Project	IEEE 802.16 Broadband Wireless Access Working Group < http://ieee802.org/16 >	
Title	CR on SDD Section 15.4: Relay with STID MAC header	
Date Submitted	2009-2-26	
Source(s)	Yoshikazu Watanabe, Nader Zein, Linghang Fan, Tetsu Ikeda, Andreas Maeder, Amir Khojastepour, Mohammad Madihian NEC	Voice: +81444317638 E-mail: y-watanabe@fa.jp.nec.com
Re:	Change request to Project 802.16m System Description Document (SDD) (IEEE 802.16m-08/003r7)	
Abstract	This contribution proposes a relaying scheme with STID MAC header.	
Purpose	To be discussed and adopted by TGM for use in the IEEE 802.16m SDD	
Notice	<i>This document does not represent the agreed views of the IEEE 802.16 Working Group or any of its subgroups. It represents only the views of the participants listed in the "Source(s)" field above. It is offered as a basis for discussion. It is not binding on the contributor(s), who reserve(s) the right to add, amend or withdraw material contained herein.</i>

Relay with STID MAC Header

Figure 1 STID MAC header example

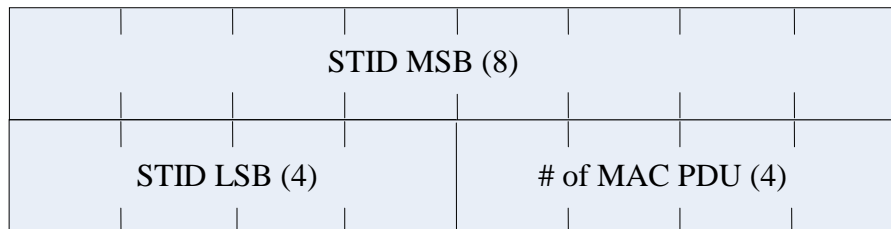
We propose to define and use STID MAC header, which includes STID, for ABS and ARS to recognize proper destination/source AMSs of MAC PDUs in a relay burst. An STID MAC header which includes an STID for an AMS is placed right before MAC PDU(s) to/from the AMS.

STID MAC header may include the number of MAC PDUs for the AMS specified by the header as well. ABS and ARS can distinguish a STID MAC header from a Generic MAC header using the number information.

- STID: This field indicates the STID of the destination/source AMS of MAC PDU(s) following this STID MAC header.
- # of MAC PDU: This field indicates the number of MAC PDUs for which this STID MAC header is valid.

A burst for relaying is generally composed of multiple MAC PDUs whose destination/source stations (AMSS and/or ARSS) are different. ABS and ARS use STID MAC header, which includes STID, to recognize the proper destination/source station of each MAC PDU. An STID MAC header which includes an STID of a station is placed right before MAC PDU(s) to/from the station. STID MAC header may also include the number of MAC PDU for the station specified by the header. The number information helps differentiation between a Generic MAC header and an STID MAC header. The presence of the first STID MAC header in a burst may be indicated by a Generic MAC header which includes a dedicated flow ID or a MAC PDU which has a dedicated extended header.

Figure 3 Relay burst example

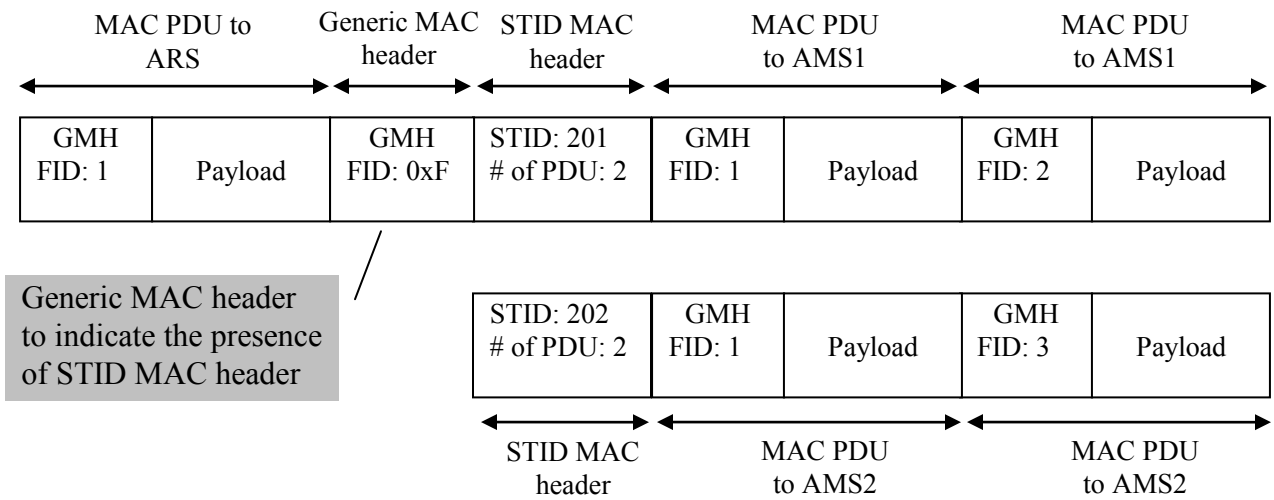
Figure 3 shows a relay burst example transmitted from the ABS to the ARS in Figure 2. The example in Figure 3 uses a dedicated flow ID (0xF) for detection of the first STID MAC header. Figure 4 also shows a relay burst example. The example in Figure 4 uses a dedicated extended header for detection of the first STID MAC header. The dedicated extended header in Figure 4 uses example type value 0x1F.
